## SUBDIVISION AUTHORITY AGENDA MEETING NO. 13

File No. LDA18-0515

RE: Tentative plan of subdivision to create 22 row housing lots and three (3) Multiple Family Lots, from the NW and SW 29-53-24-W4M, located north of 137 Avenue NW and east of Castle Downs Road NW; GRIESBACH

April 4, 2019 File No. LDA17-0722

LDA18-0515

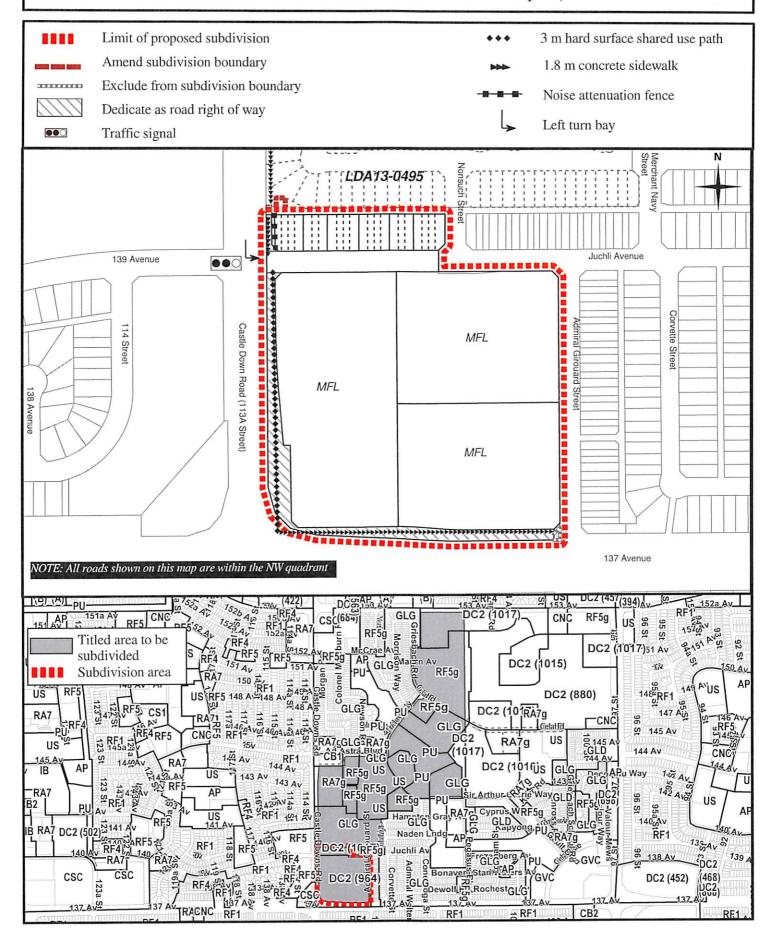
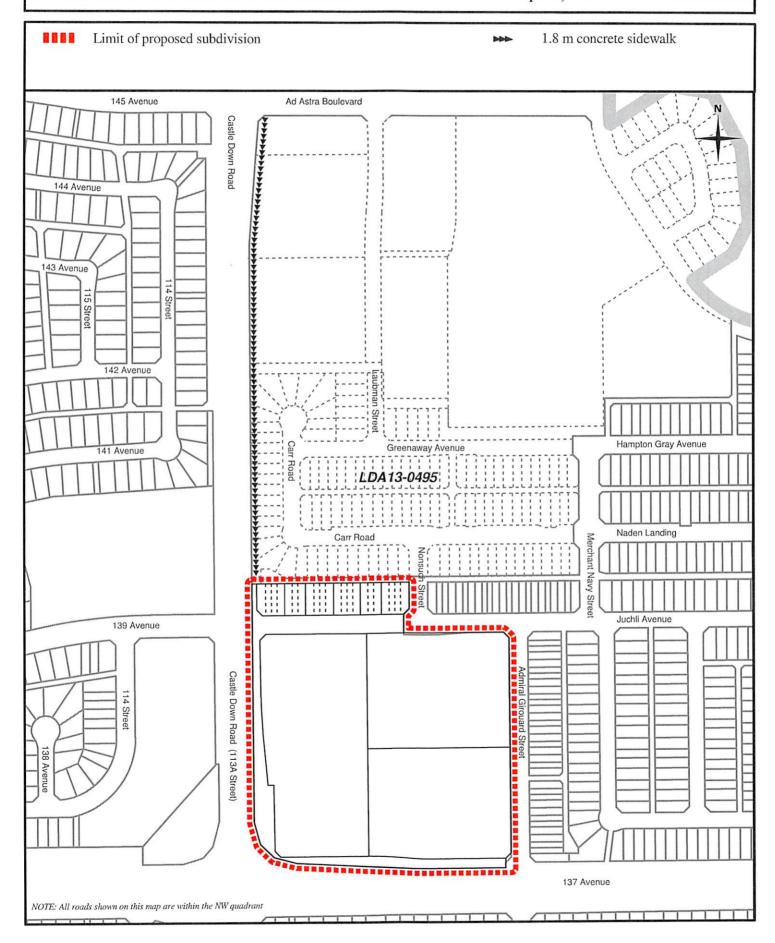
- that the owner dedicate road right of way to conform to an approved Concept Plan or to the satisfaction of Subdivision and Development Coordination and Integrated Infrastructure Services for 137 Avenue NW and Castle Downs Road NW, as shown on the "Conditions of Approval" map, Enclosure I;

- 4. that the subdivision boundary of the residential lot flanking Castle Downs Road be expanded northerly to accommodate the noise attenuation fence, to the satisfaction of Subdivision and Development Coordination, as shown on the "Conditions of Approval" map, Enclosure I;

- 5. that the subdivision boundary be amended to exclude the southeast corner cut located at 137 Avenue and Admiral Girouard Street intersection, as shown on the "Conditions of Approval" map, Enclosure I;

- 7. that the owner constructs a 3 m hard surface shared use path on Castle Downs Road NW, to the satisfaction of Subdivision and Development Coordination, as shown on the "Conditions of Approval" map, Enclosures I;

- 8. that the owner constructs a 1.8 m concrete sidewalk, to the satisfaction of Subdivision and Development Coordination, as shown on the "Conditions of Approval" map, Enclosure I and II;

- 9. that the owner construct a left turn bay including median modifications, to the satisfaction of Subdivision and Development Coordination, as shown on the "Conditions of Approval" map, Enclosure I:

- 10. that the owner construct a 1.8 m noise attenuation fence contained wholly within private property, for all lots flanking onto Castle Downs Road, as per the City of Edmonton Roadway Design Standards Drawing #5205, to the satisfaction of Subdivision and Development Coordination, as shown on the "Conditions of Approval" map, Enclosure I;

- 11. that the owner pay for the installation of a traffic signal, as shown on the "Conditions of Approval" map, Enclosure I. The City of Edmonton shall complete the signal design, and the City's Electrical Services Contractor must install the signals as per the agreement between the City of Edmonton and the Electrical Services Contractor. The timing of the traffic signals installation will be at the direction of Transportation Operations. If traffic signals are not deemed warranted by Transportation Operations within 5 years of signing the Servicing Agreement, the owner will be required to provide payment to the City of Edmonton for the installation of traffic signals at that time to fulfill this obligation; and

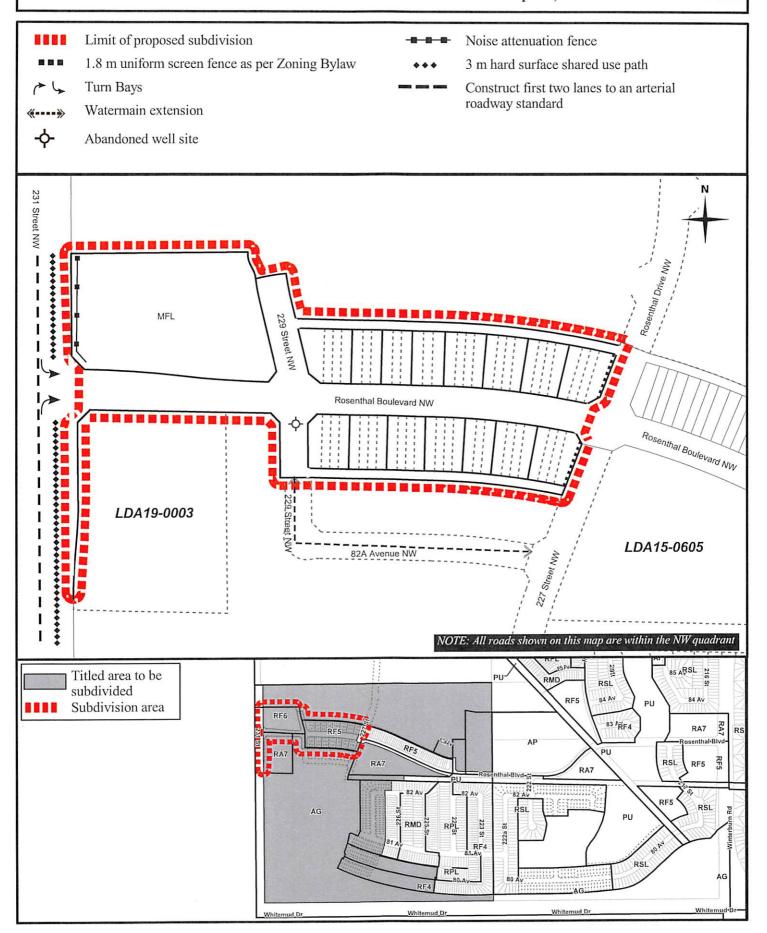
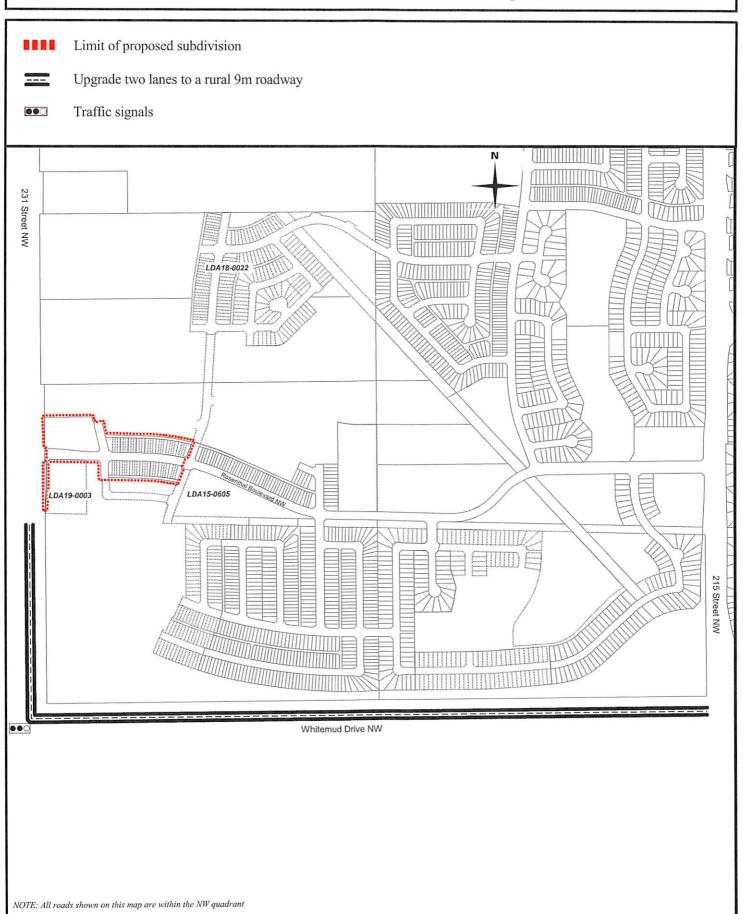
- 7. that the owner pay for the installation of traffic signals, as shown on the "Conditions of Approval" map, Enclosure II. The City of Edmonton shall complete the signal design, and the City's Electrical Services Contractor must install the signals as per the agreement between the City of Edmonton and the Electrical Services Contractor. The timing of the traffic signals installation will be at the direction of Transportation Operations. If traffic signals are not deemed warranted by Transportation Operations within 5 years of signing the Servicing Agreement, the owner will be required to provide payment to the City of Edmonton for the installation of traffic signals at that time to fulfill this obligation;

- 8. that the engineering drawings include identification of the abandoned well site, demonstrating that a 4 m drive aisle will be available should the 10 m x 15 m working area be occupied due to well repairs, to the satisfaction of Subdivision and Development Coordination, as shown on the "Conditions of Approval" map, Enclosure I;

- 9. that the engineering drawings include the upgrade of the first two lanes of 231 Street NW from the north subdivision boundary to the future Public Utility Lot to an arterial roadway standard, including channelization, intersections, turn bays, 3 m shared use path on the east side, lighting, landscaping and any transitional improvements, to the satisfaction of Subdivision and Development Coordination, as shown on the "Conditions of Approval" map, Enclosure I;

- 10. that the engineering drawings include the upgrade of the first two lanes of 231 Street NW from the future Public Utility Lot to Whitemud Drive and the first two land of Whitemud Drive from Winterburn Road (215 Street NW) to 231 Street NW to a rural 9 m wide arterial roadway standard, including channelization, accesses, lighting, landscaping and any transitional improvements, to the satisfaction of Subdivision and Development Coordination, as shown on the "Conditions of Approval" map, Enclosure II;

- 13. that the owner constructs an offsite watermain extension, to the satisfaction of EPCOR Water Services Inc., as shown on the "Conditions of Approval" map, Enclosure I;
- 14. that the owner construct a 1.8 m noise attenuation fence contained wholly within private property, in conformance with the submitted noise study, for the multifamily lot backing onto 231 Street NW, to the satisfaction of Subdivision and Development Coordination, as shown on the "Conditions of Approval" map, Enclosure I;
- 15. that the owner construct all fences wholly on privately-owned lands, to the satisfaction of Subdivision and Development Coordination, as shown on the "Conditions of Approval" map, Enclosure I; and
- 16. that the owner is responsible for the landscape design and construction within road rights of way, to the satisfaction of City Departments and affected utility agencies.

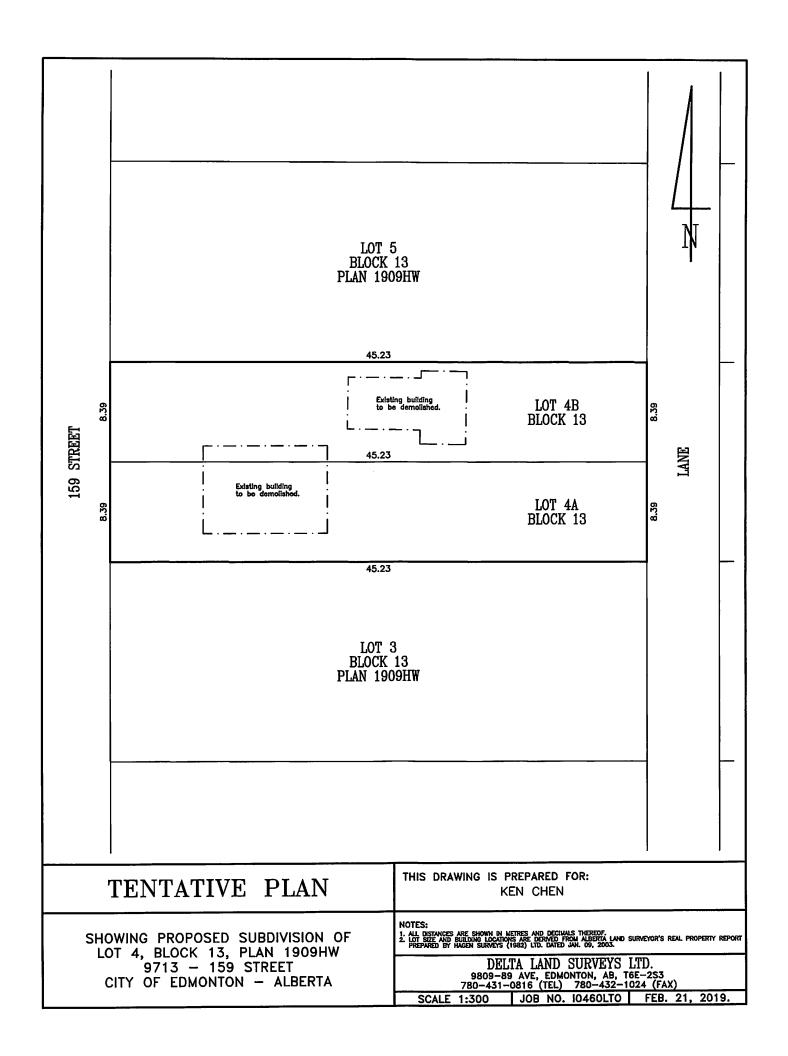
- There are existing boulevard trees adjacent to the site on 159 Street NW that must be protected during construction. For information about tree protection please refer to the City of Edmonton's website (Trees and Construction).
- Access for future development must be to the adjacent alley in conformance with the Mature Neighbourhood Overlay Sec. 814.3(17) of the Zoning Bylaw #12800.
- There is an existing access to 159 Street NW. Upon redevelopment of proposed Lot 4B, the
  existing residential access to 159 Street NW must be removed. The owner/applicant will be
  required to obtain a Permit to remove the access, available from Development and Zoning
  Services, 2nd Floor, 10111 104 Avenue NW.

- The existing services (water and sanitary) enter the proposed subdivision approximately 11.8 m south of the north property line of Lot 4 off 159 Street NW. As per the EPCOR Drainage Services Bylaw and the EPCOR Water Services and Wastewater Treatment Bylaw, these services cannot cross the proposed property line.

- There is a deficiency in on-street hydrant spacing adjacent to the property. The applicant/owner is advised to review on-site fire protection requirements to ensure adequate coverage (contact EPCOR Water at 780-412-3955).

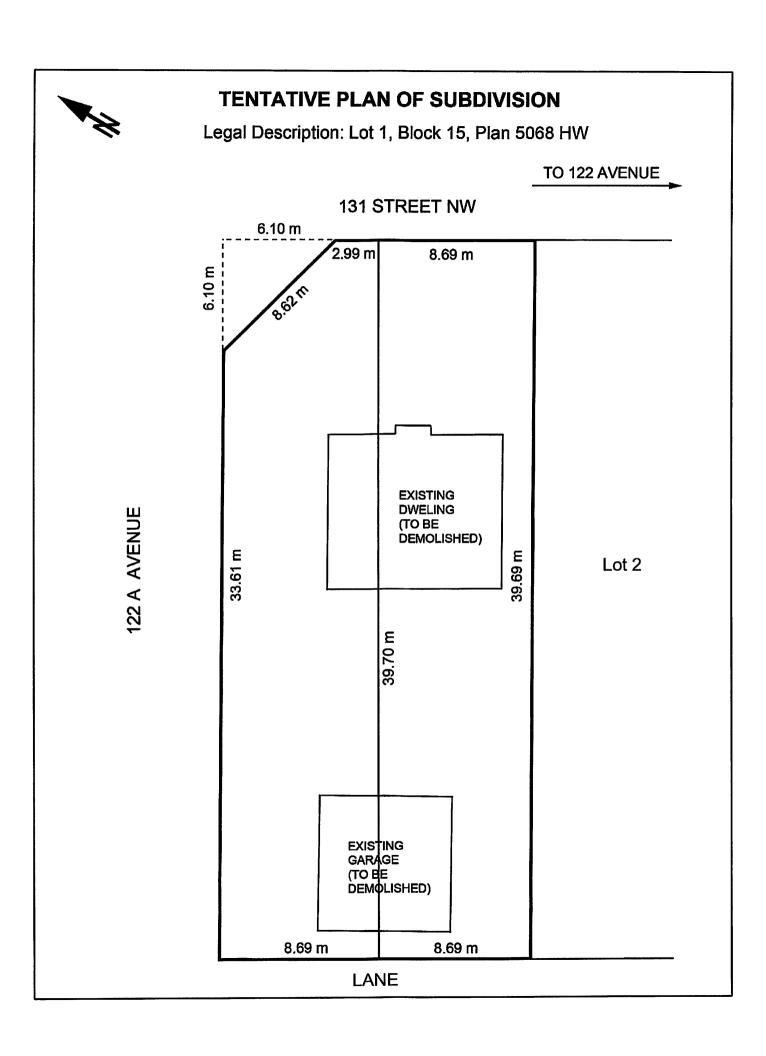
- There are existing boulevard trees adjacent to the site on 131 Street NW and 122A Avenue NW
  that must be protected during construction. For information about tree protection please refer
  to the City of Edmonton's website (Trees and Construction).
- Access for future development must be to the adjacent alley in conformance with the Mature Neighbourhood Overlay Sec. 814.3(17) of the Zoning Bylaw #12800.
- There is an existing access to 122A Avenue NW. Upon redevelopment of the northernmost proposed lot, the existing residential access to 122A Avenue NW must be removed. The owner/applicant will be required to obtain a Permit to remove the access, available from Development and Zoning Services, 2nd Floor, 10111 - 104 Avenue NW.

- The existing services (water and sanitary) enter the proposed subdivision approximately 6.5 m south of the north property line of Lot 1 off the lane. The existing storm service enters the proposed subdivision approximately 8.35 m south of the north property line of Lot 1 off 131 Street NW. As per the EPCOR Drainage Services Bylaw and the EPCOR Water Services and Wastewater Treatment Bylaw, these services cannot cross the proposed property line.
